ADDENDUM #3

January 14, 2025

East Calais Post Office & Moscow Woods Road Gully East, Vermont

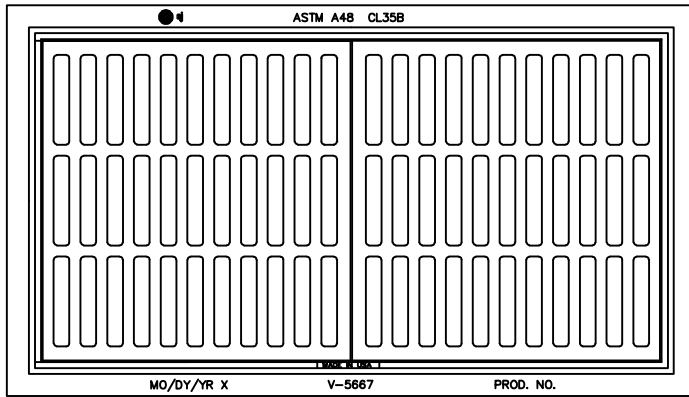
The depth of sump for the drywell, storm manhole, and catchbasin is 2.5 feet minimum below the outlet pipe.

V5667 Assembly

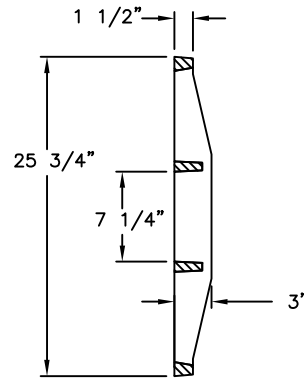
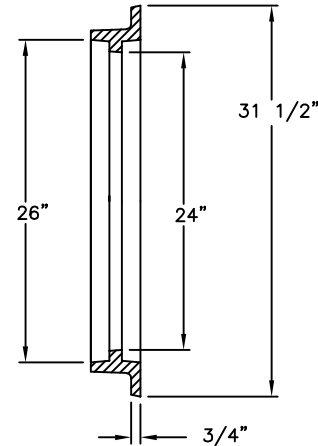
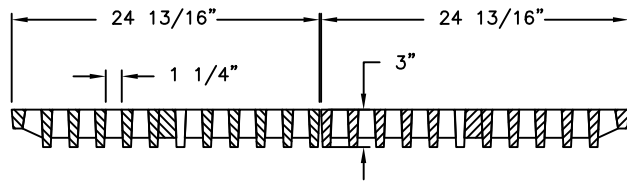
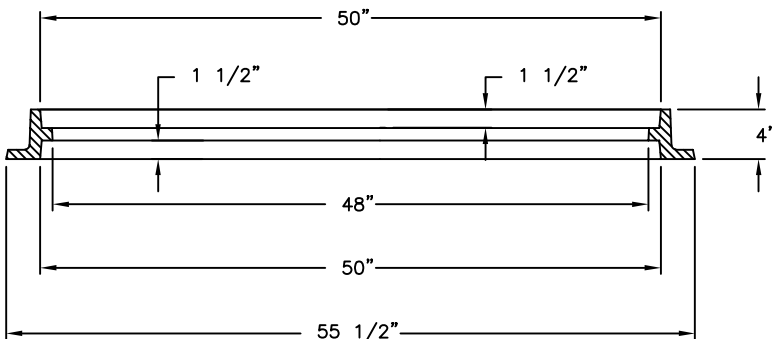
The inlet grate called out for the dry well and catch basins can be substituted with attached 24" by 48" with structure top adjusted to alternative shape. See attached alternative detail. Inlet grate called out on plans continues to be acceptable.
